2 PROJECT DESCRIPTION

This section of the Environmental Impact Report (EIR) describes SDG&E's Sycamore-Peñasquitos 230-kV Transmission Line Project (Proposed Project) in detail.

2: Project Description
Administrative Draft Environmental Impact Report

Figure 2.1-1: Project Location

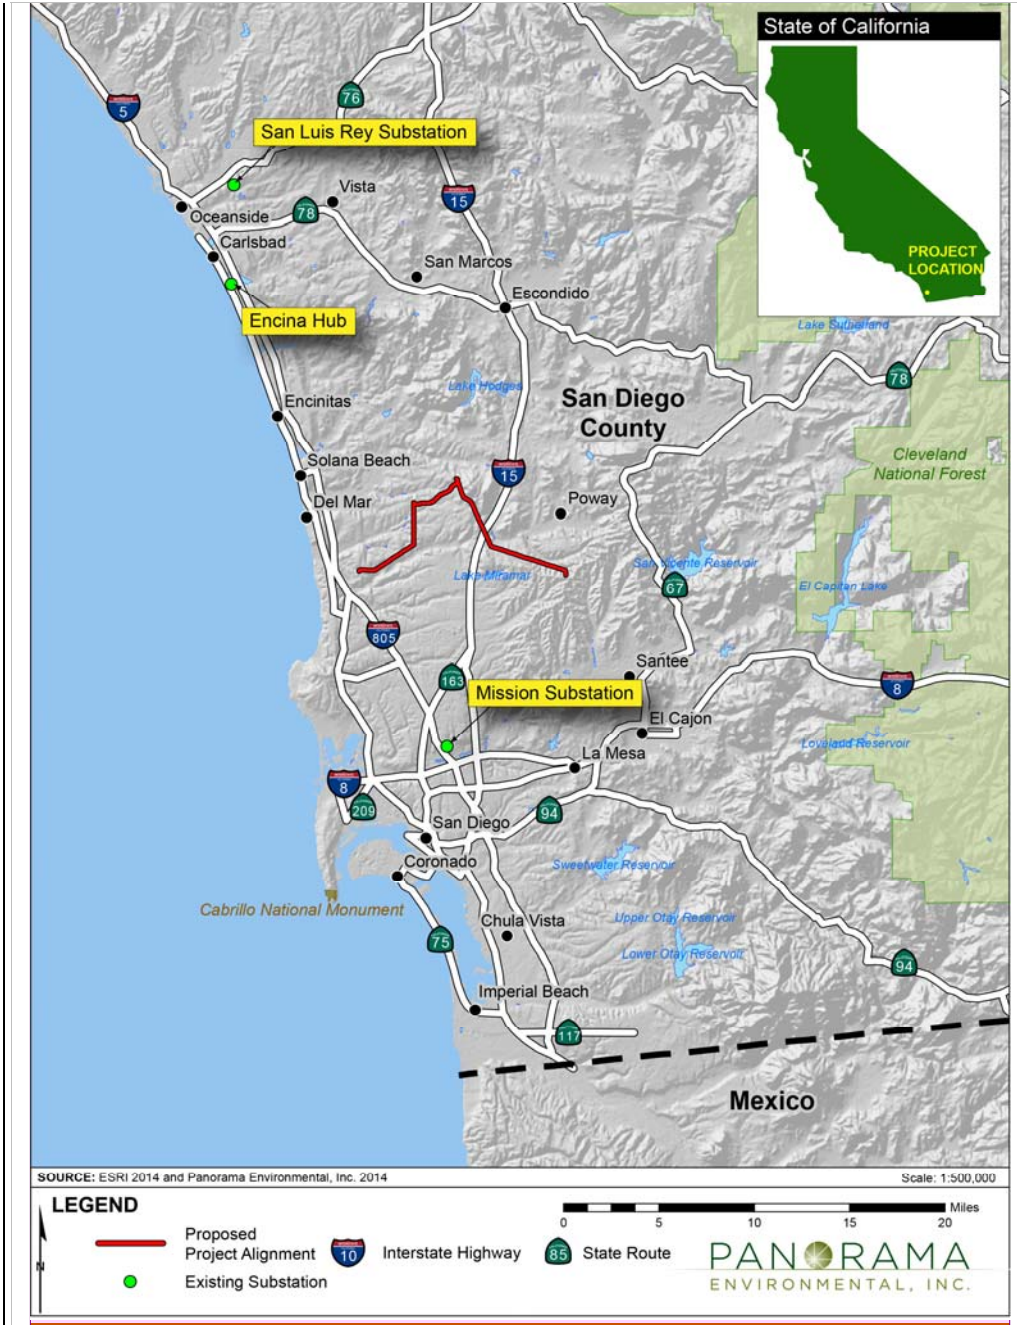
Comment [CD1]: Need to add the location of the pole work in Mira Mesa for the Mission-SLR Transposition

Figure 2.1-2: Project Alignment Overview

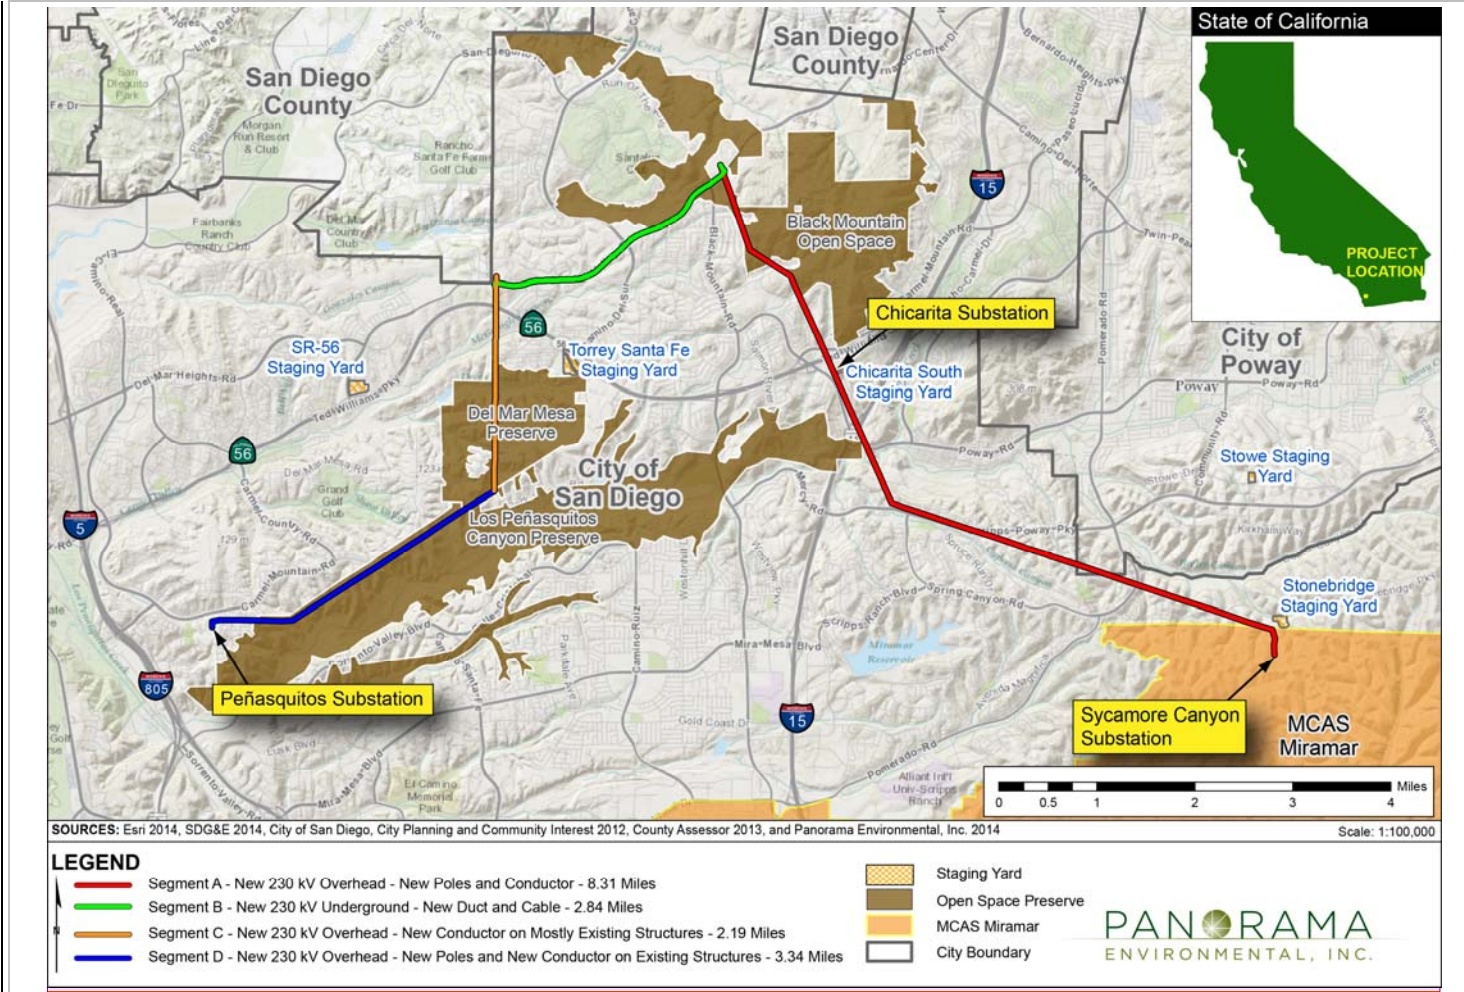
Comment [CD2]: Revise map to include the Evergreen and Black Mountain Ranch Community Park staging yards

Figure 2.3-1a: Diagram of Proposed 69-kV TSP

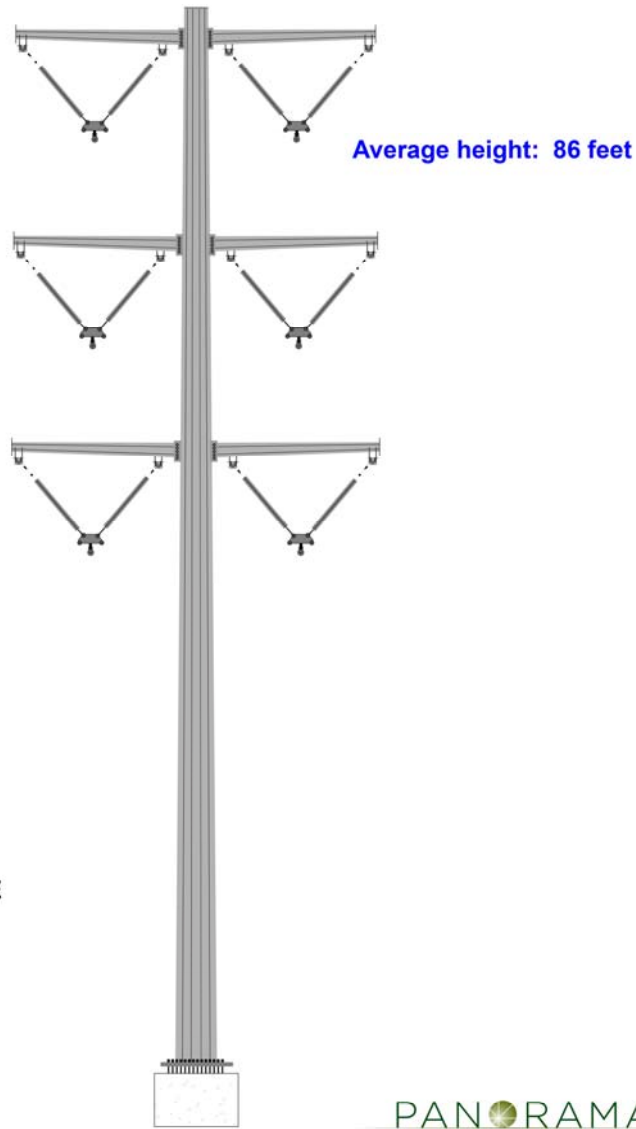
Comment [GV9]: Update avg per table above

Figure 2.3-1c: Diagram of Proposed 230-kV Tangent Double-Circuit TSP

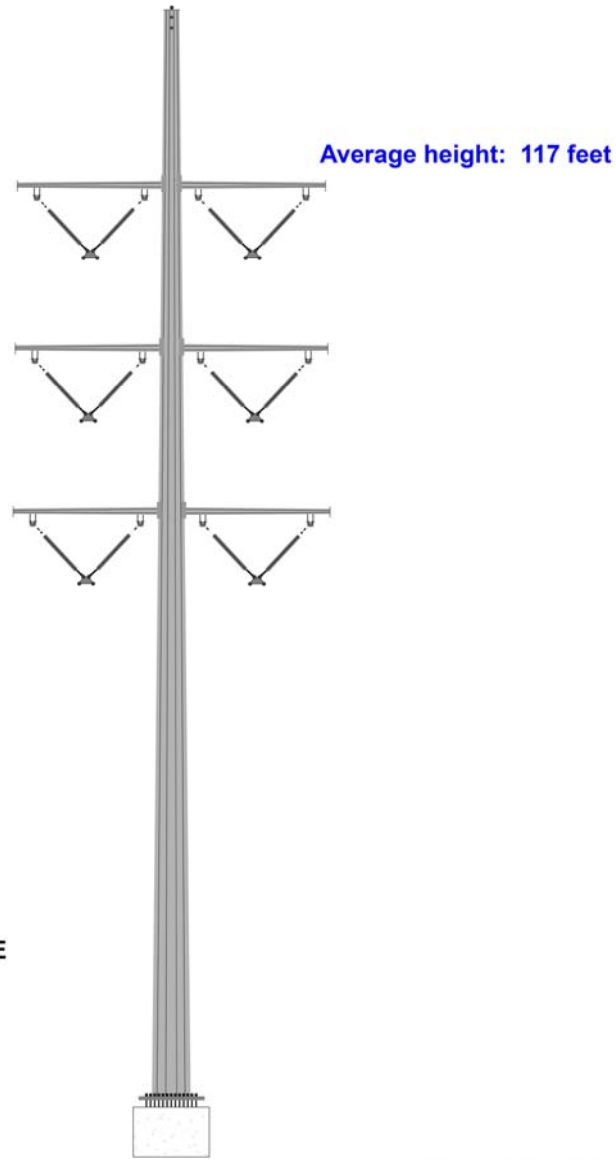
Comment [GV10]: Update avg. height

Figure 2.3-1e: Diagram of Proposed 230-kV Underground Double-Circuit Cable Pole

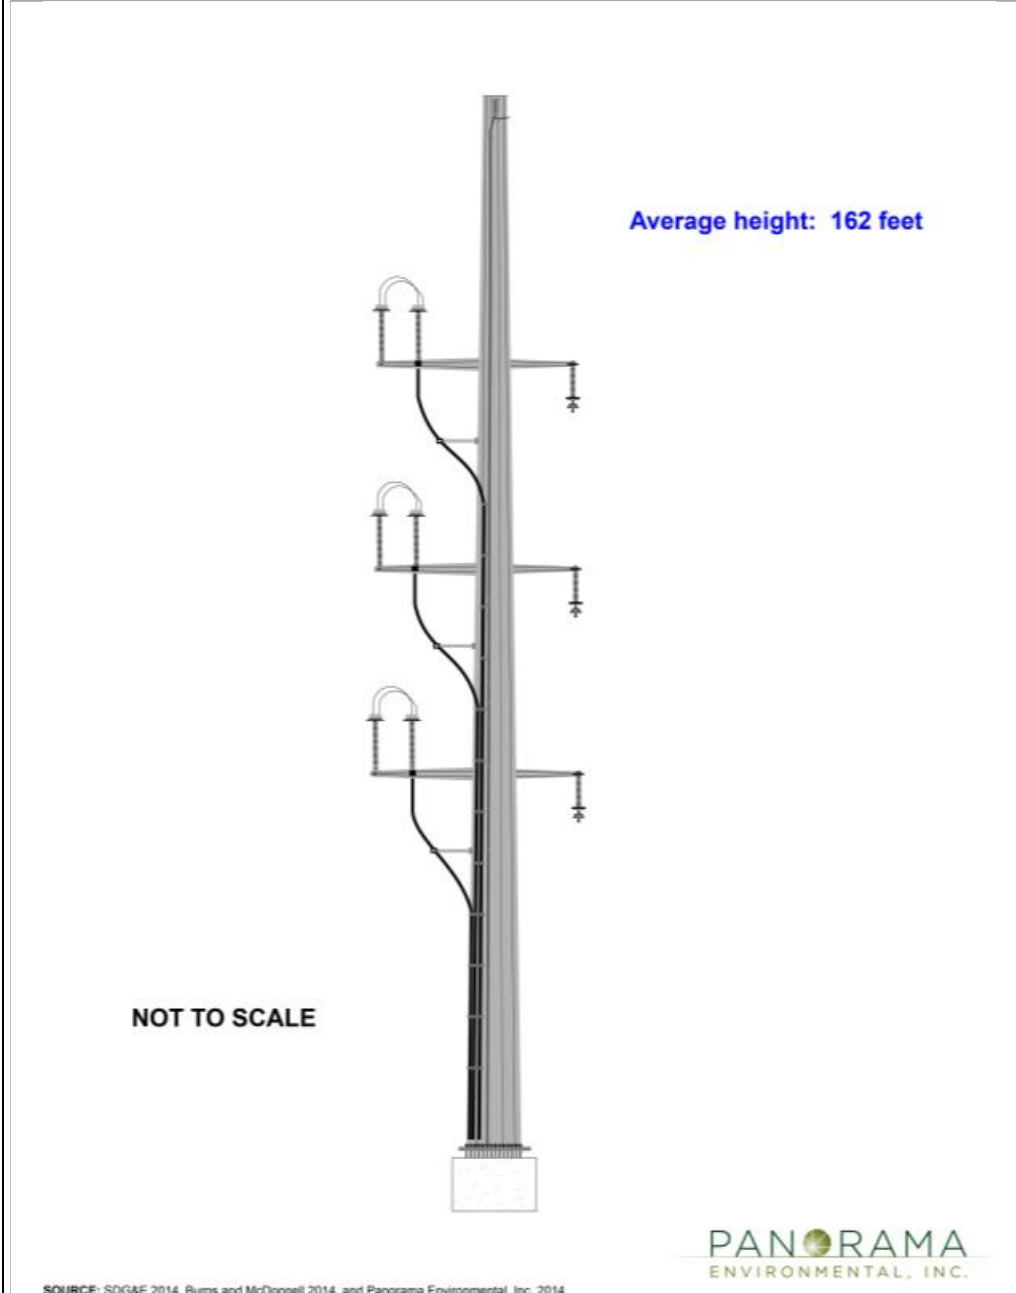
Comment [JDT11]: Update average height.

Figure 2.3-6b: Segment A Existing and Proposed Configurations

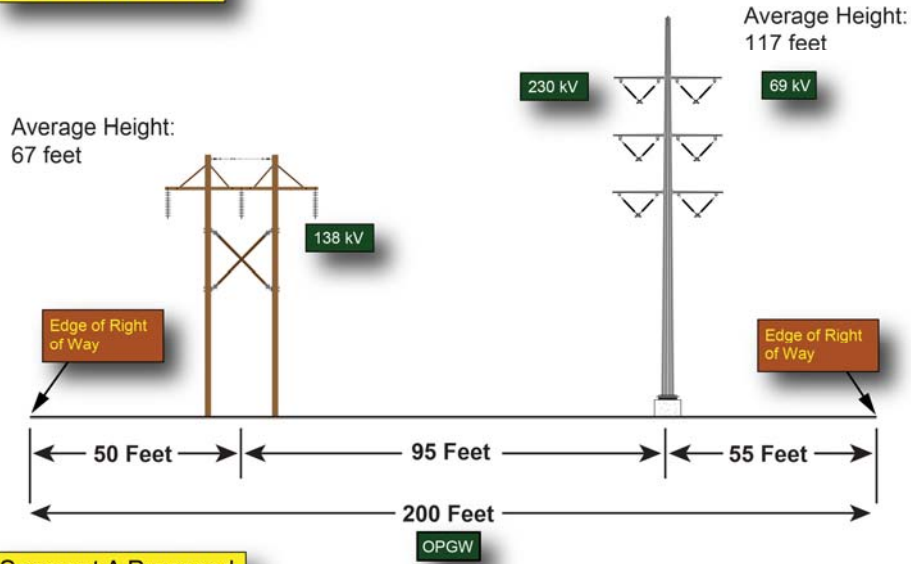
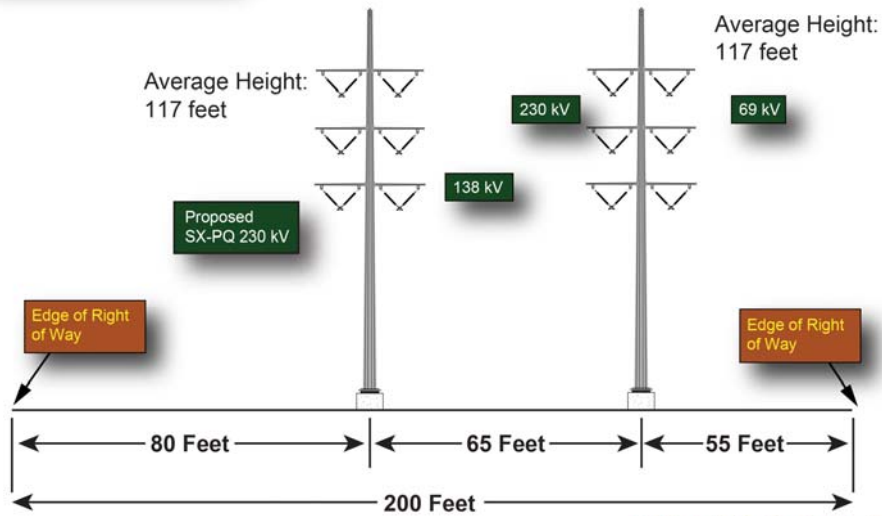
Comment [GV14]: 23051 TSP avg 136'
 sxpq tsp avg =121'

Figure 2.3-8: Typical Segment B Duct Bank Diagram

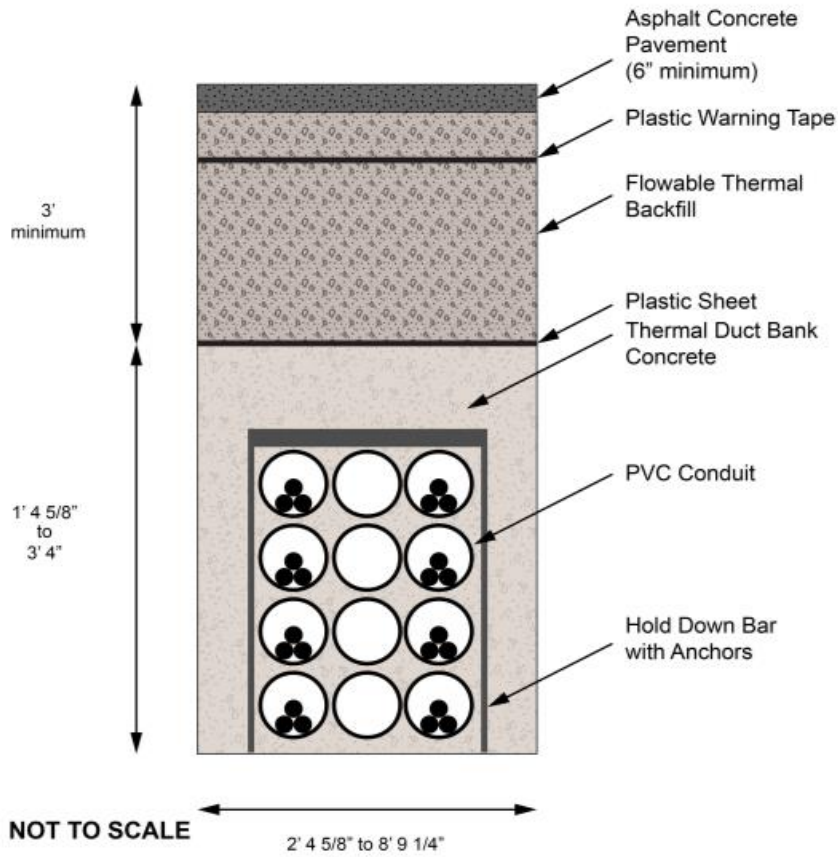
Comment [JDT23]: Replace with Attachment ED05 - Q1(b)_Trench Diagram

Figure 2.3-9: Segment C Existing and Proposed Configurations

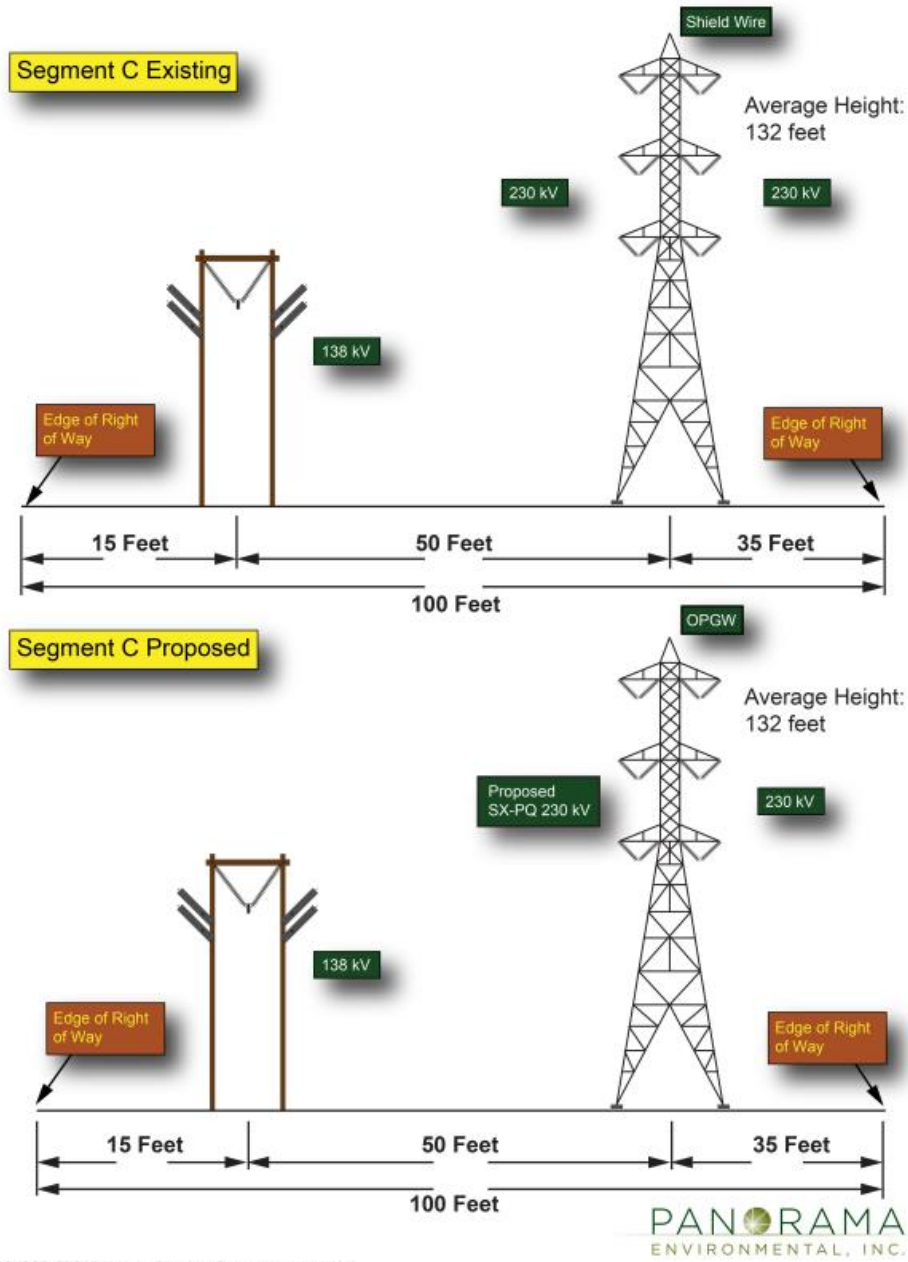
Comment [JThomas26]: Data Need: Need average height of existing 138kV H frame poles.

Comment [GV27]: Avg Hts of H-Frames =56.5 avg ht of lattice tower = 127.5

Figure 2.3-10: Segment D Existing and Proposed Configurations

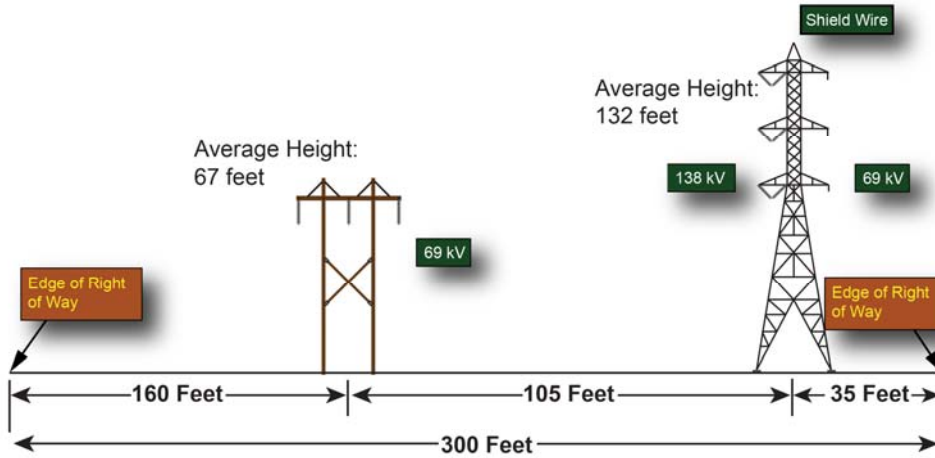
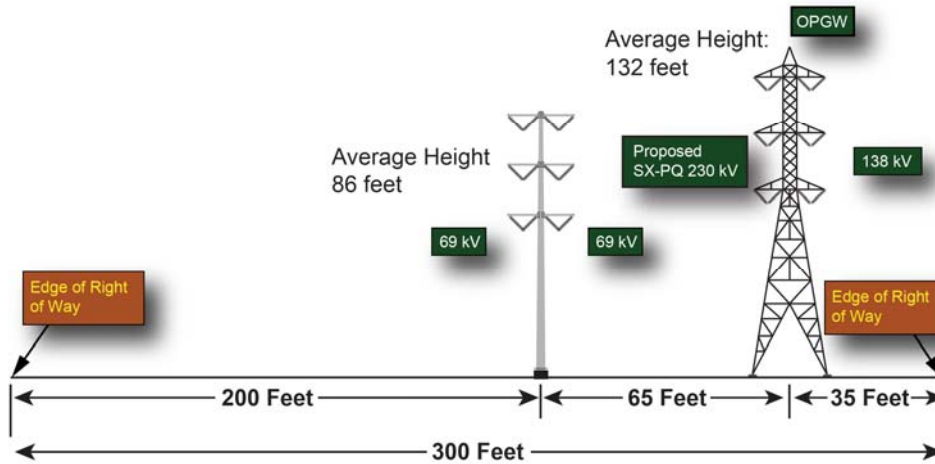
Comment [GV34]: Need TL675 avg heights
 Lattice Tower avg = 124'
 New TSP avg ht = 97'
